VKM 22380/22385

Technical Bulletin - January 2010

PSA, FIAT, RENAULT, OPEL, VAUXHALL, SEAT – Sofim engines

OE/SKF DESIGN EVOLUTION

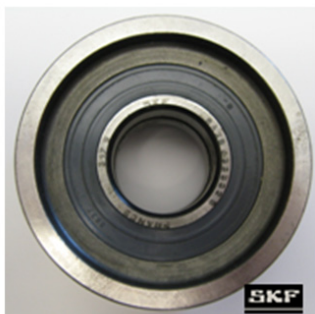
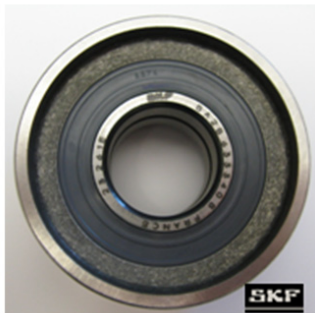
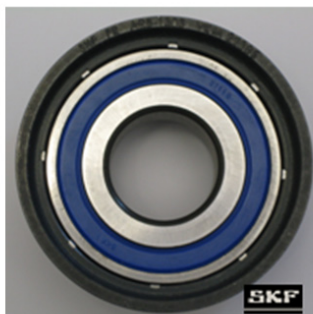
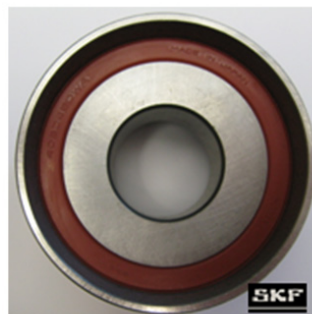
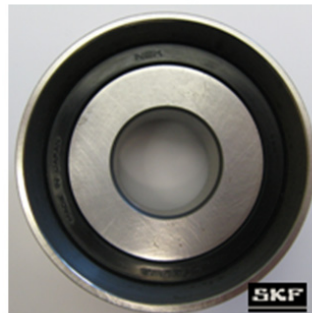
The above car makers have changed the design of two engine idlers → SKF corresponding part numbers: VKM 22380 and VKM 22385.

To follow car makers' specifications, SKF has also modified their idler designs.

The **double inner ring** has been replaced by **one inner ring** to avoid mounting problems.

Old OE/SKF Design
2 inner rings

New SKF Design
1 inner ring

New OE Design
